PECOS DISTRICT CONDITIONS OF APPROVAL

OPERATOR'S NAME:	MEWBOURNE OIL
LEASE NO.:	NM78273
WELL NAME & NO.:	1H-MARATHON ROAD 14 NC FEDERAL
SURFACE HOLE FOOTAGE:	0170'/N. & 1980'/W.
BOTTOM HOLE FOOTAGE	0330'/N. & 2310'/W.
LOCATION:	Section 23, T. 20 S., R. 34 E., NMPM
COUNTY:	Lea County, New Mexico

Figure 1 – Cross Sections and Plans For Typical Road Sections

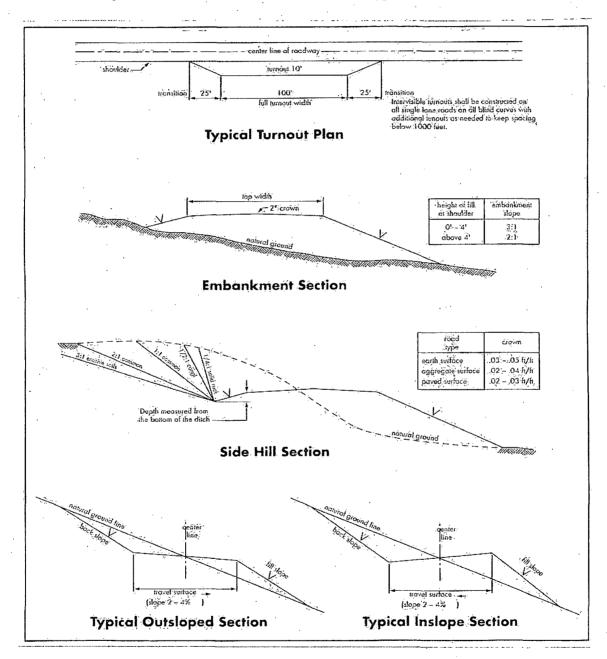
Crowning shall be done on the access road driving surface. The road crown shall have a grade of approximately 2% (i.e., a 1" crown on a 14' wide road). The road shall conform to Figure 1; cross section and plans for typical road construction.
